**MONTGOMERY COUNTY HISTORIC PRESERVATION COMMISSION**  
**STAFF REPORT**

<b>Address:</b>	3806 Williams Lane, Chevy Chase	<b>Meeting Date:</b>	3/26/2025
<b>Resource:</b>	Master Plan Site #35/76 <b>Williams-Wirgman House</b>	<b>Report Date:</b>	3/19/2025
<b>Applicant:</b>	Pat and Wyman Stokes (Shawn Buehler, Architect)	<b>Public Notice:</b>	3/12/2025
<b>Review:</b>	HAWP	<b>Tax Credit:</b>	Partial
<b>Permit No.:</b>	1104437	<b>Staff:</b>	Laura DiPasquale
<b>Proposal:</b>	Partial demolition, construction of new two-story rear addition, new detached accessory structure; tree removal; siding, window and roof replacement

**STAFF RECOMMENDATION**

Figure 4: The preliminary consultation site plan (left) and current proposed site plan (right).

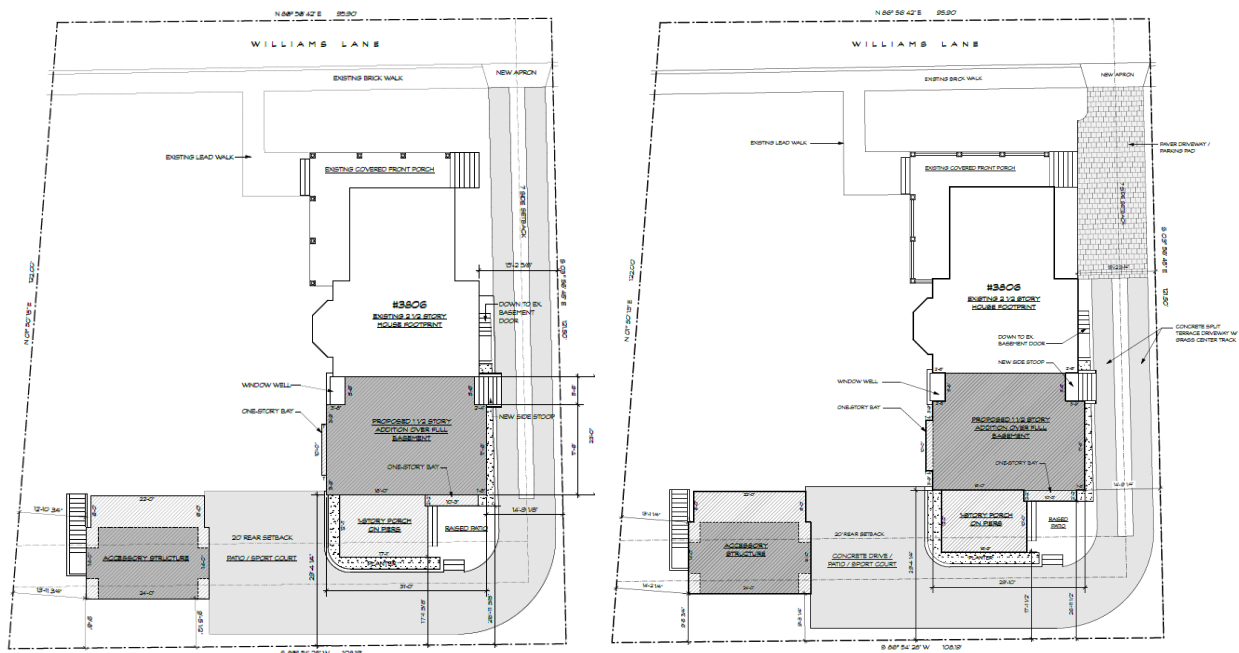
- *HAWP submission: Additional details and materials specifications have been provided.*
- The placement of the driveway is appropriate.
  - *HAWP submission: The driveway material and design has been modified to show a full-width paver driveway for the first approximately 30 feet before transitioning to a double-track. Additional details and materials specifications have been provided.*

Figure 6: West elevation as proposed in the preliminary consultation design (above), and current proposal (below). The red box in the gable end window shows the approximate staff-recommended window size.

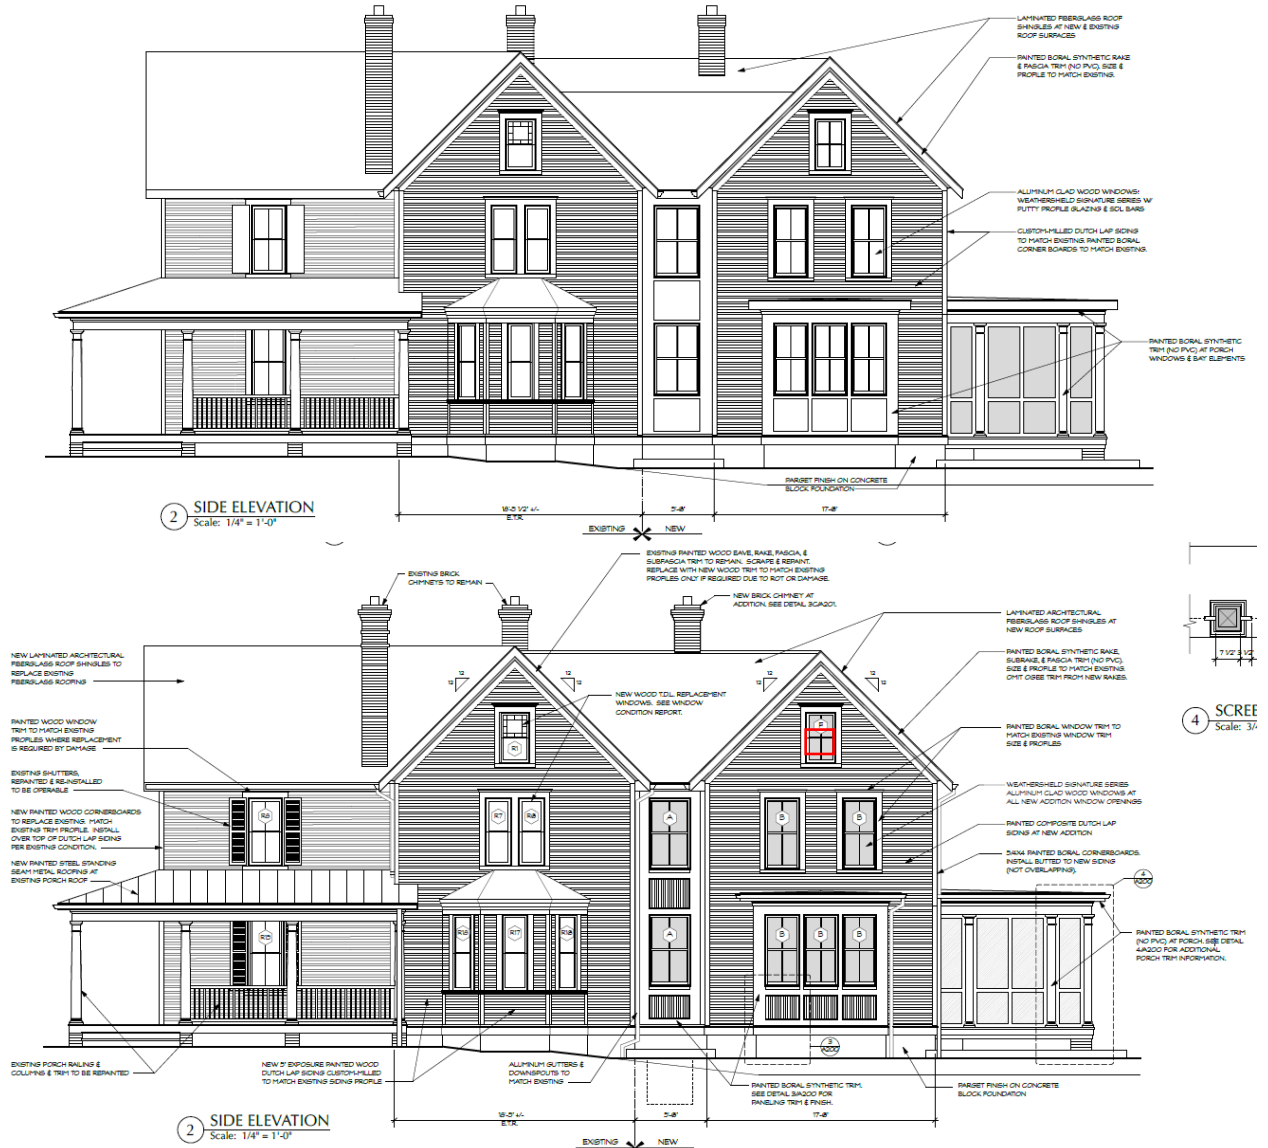
- In addition to the overall plane setbacks, the details of the west elevation warrant additional consideration. Commissioner Hains opined that the use of a flat bay on the west elevation is acceptable because is shallower than the historic bay. Commissioner Radu commented that the design of the west gable elevation competes too much with the historic house. Commissioner Galway added that the design should not look too historic and should be further differentiated from the old so that it is obvious that the addition came later.

- *HAWP submission: The proposed first-floor bay on the west elevation has been pulled back slightly less than the overall wall plane, and now projects 1-foot 4-inches as opposed to the previously-proposed 1-foot projection. No other changes were made to the elevation.*

Staff finds, however, that some details in the current submission do not fully address the HPC's concerns and warrant additional consideration. While beadboard has been added to the panels in the hyphen and bays, the overall proportions of the panels, trim and fenestration have not been modified. Staff recommends that the applicant widen the windows proposed in the hyphen and add a single or dual sidelights to the entry door to provide additional glazing as recommended during the preliminary consultation review and further differentiate the new from the old, in keeping with *Standard 9*. Staff finds that, while the west elevation of the proposed addition has been pulled back, the proposed flat bay projects an additional 4 inches than previously-proposed (from 1 foot to 1 foot, 4 inches), and that the appearance of the west elevation of the addition still competes with the historic elevation. To highlight the primacy of the historic house, staff recommends that the third-floor gable-end windows of the addition be reduced in scale to four-light casement, fixed, or awning windows no greater in size than the existing rectangular Queen Anne window on the east elevation gable end of the historic house (*Figure 6* and *Figure 7*).

3. The third-floor gable-end windows of the addition must be reduced in scale to four-light casement, fixed or awning windows no greater in size than the existing rectangular Queen Anne window on the east elevation gable end of the historic house.

Figure 7: East elevation as shown in the preliminary consultation review (above) and the current proposal (below). The red box in the gable end window shows the staff-recommended window size.

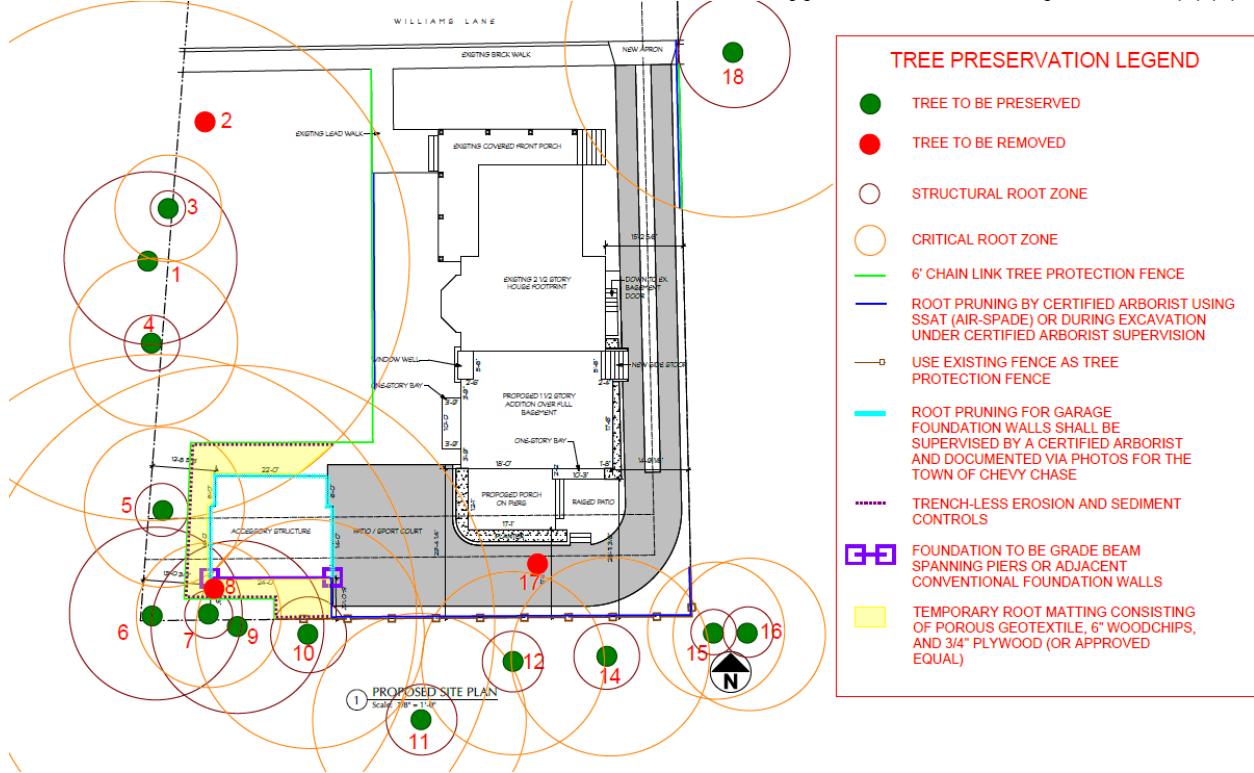
- The projection of the second-floor closet over the entry vestibule in the hyphen on the east elevation should be reduced. Chair Burditt suggested that the projection be eliminated entirely and replaced with a traditional porch roof over the entry.

- *HAWP submission: The second floor of the hyphen on the east elevation has been pulled back to align with the first floor. A traditional porch roof has been added over the entry.*

Figure 11: Proposed front elevation of the historic house.

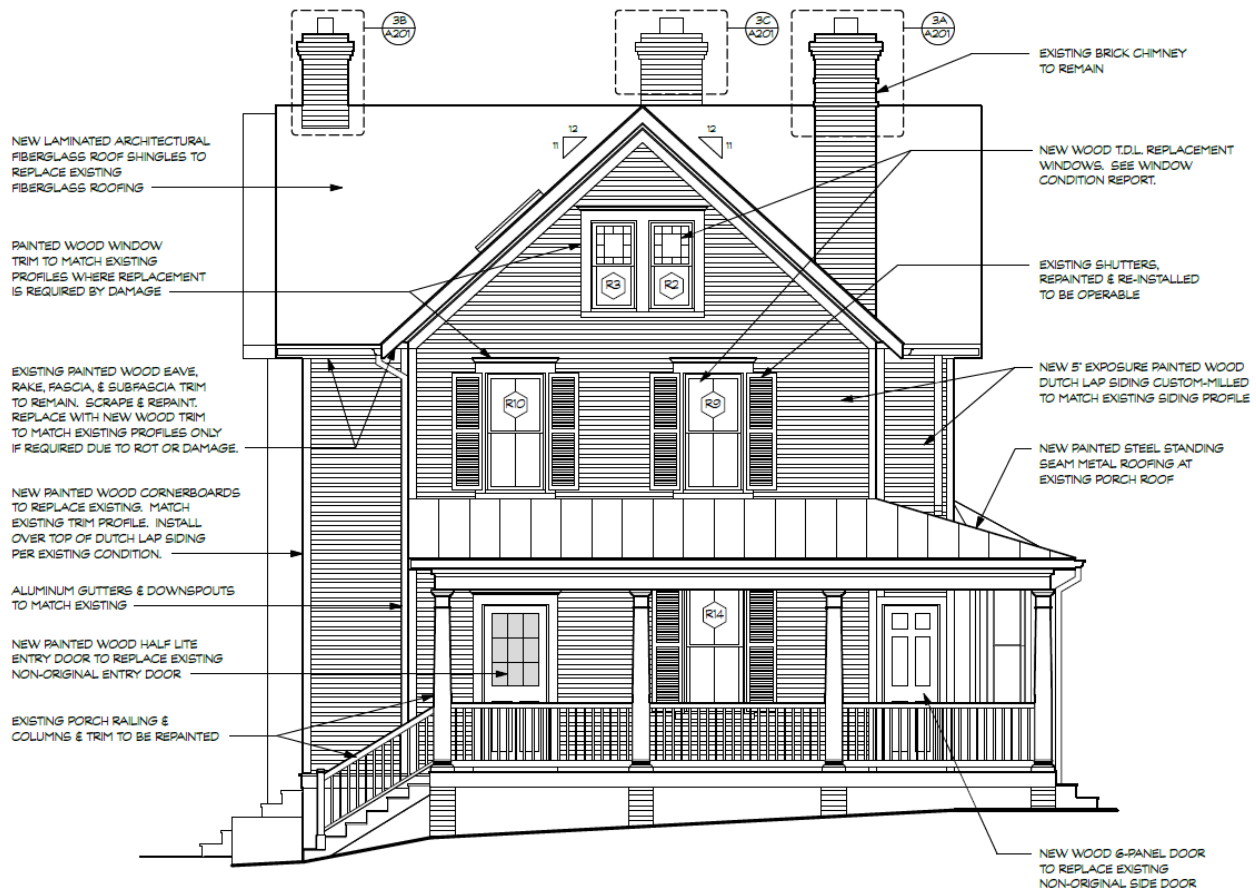
**Shutters:** The application drawings call for the reinstallation of existing shutters (*Figure 11* and *Figure 16*), to be operable, but does not show the proposed shutter hardware (*Figure 15*). Staff notes that many of the existing windows retain their original shutter hardware and recommends that this hardware be retained and reused, pursuant to *Standard 6*.

6. The presence and condition of the shutter hardware must be added to the window survey. The historic shutter hardware must be retained on all windows where it exists.

Figure 12: Proposed double-hung “narrow rail” window details.

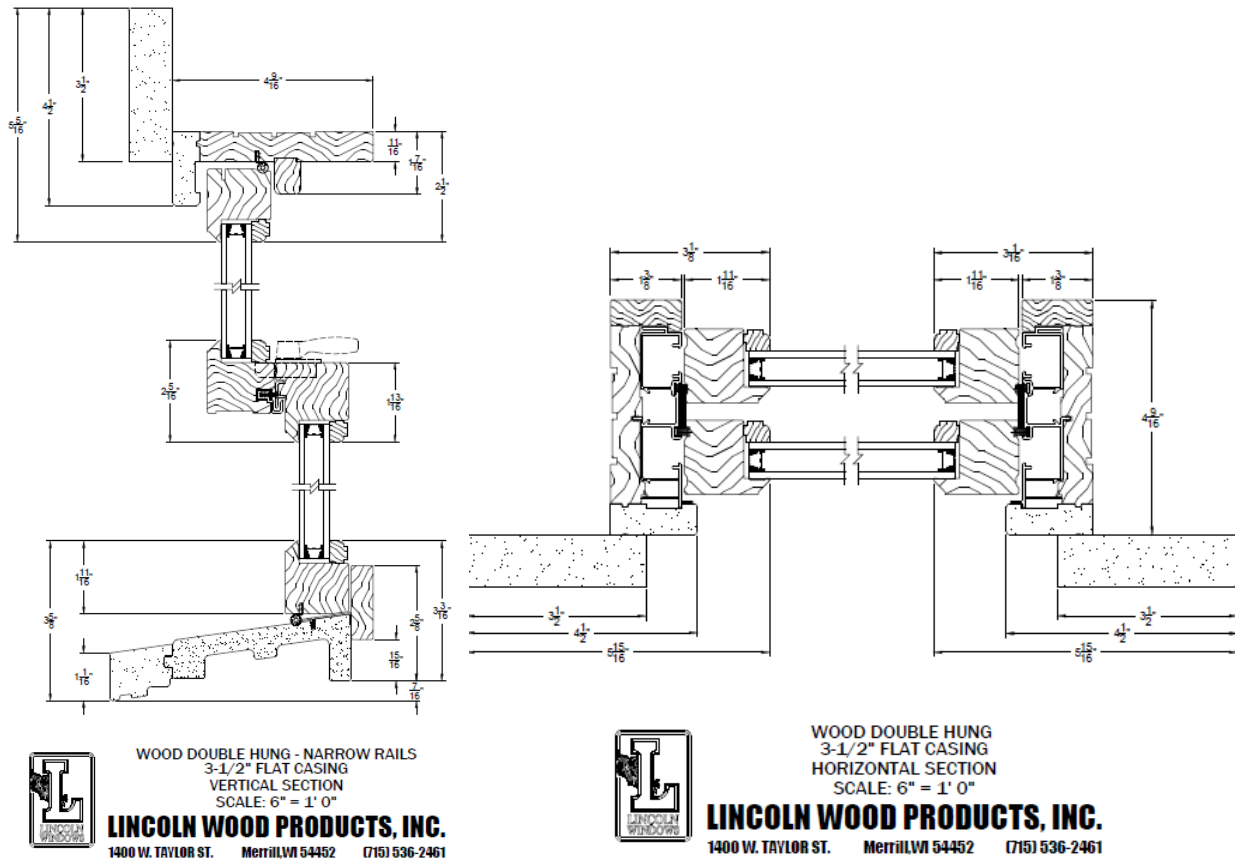
**Window replacement:** The applicants have provided a window condition survey and proposed replacement drawings for each window. Staff finds that the applicants have adequately demonstrated that most of the windows are in poor condition, but not that the proposed windows are an in-kind replacement to match the historic details, in keeping with *Standard 6*. For example, for the proposed double-hung windows, the proposed “narrow rail” bottom rail is only 1-11/16 inches (Figure 12), where the existing is over 3 inches (Figure 13, right).

5. The applicant must submit additional and precise documentation and updated window specifications confirming the dimensions for all window types. The proposed windows must match exactly the dimensions of the historic windows.
